# Technical Service Bulletin

**NUMBER:** 09-08-99

**THIS BULLETIN SUPERSEDES TECHNICAL SERVICE BULLETIN 09-05-98, DATED NOV. 6, 1998, WHICH SHOULD BE REMOVED FROM YOUR FILES AND NOTED IN THE 1998 TECHNICAL SERVICE BULLETIN MANUAL (PUBLICATION NO. 81-699-99003). ALL REVISIONS ARE HIGHLIGHTED WITH **\*\*ASTERISKS\*\*** AND INCLUDE PART NUMBER REVISIONS AND MODEL ADDITIONS.**

Multi-Layer Steel (MLS) Head Gasket Installation Procedures

**FIGURE 1**

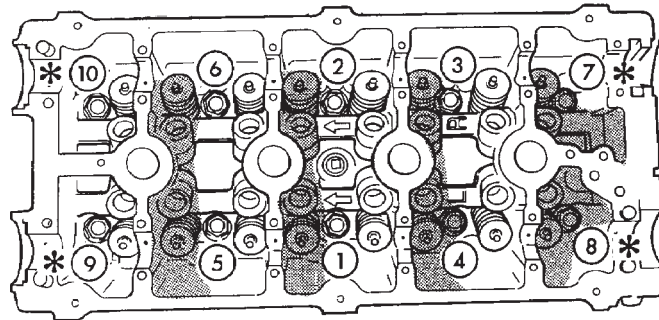
**NOTE: THE 2.0L DOHC TORQUE AND TORQUEING PROCEDURE HAS CHANGED WITH THE INSTALLATION OF A MLS GASKET. USE THE FOLLOWING PROCEDURES FOR THE 2.0L DOHC ONLY.**

**NOTE: THE 4 SHORT BOLTS ARE PLACED IN THE CORNERS.**

- A. Torque all center bolts to 34 Nm (25 Ft Lbs), Torque the 4 corner bolts to 27 Nm (20 Ft Lbs) see Fig 1 for torque sequence.
- B. Torque all center bolts to 68 Nm (50 Ft Lbs), Torque the 4 corner bolts to 47 Nm (35 Ft Lbs) see Fig 1 for torque sequence.
- C. Re-torque all center bolts to 68 Nm (50 Ft Lbs), Re-torque the 4 corner bolts to 47 Nm (35 Ft Lbs) see Fig 1 for torque sequence.
- D. Tighten all bolts in the specified sequence (Fig 1) an additional 90° (1/4 turn).
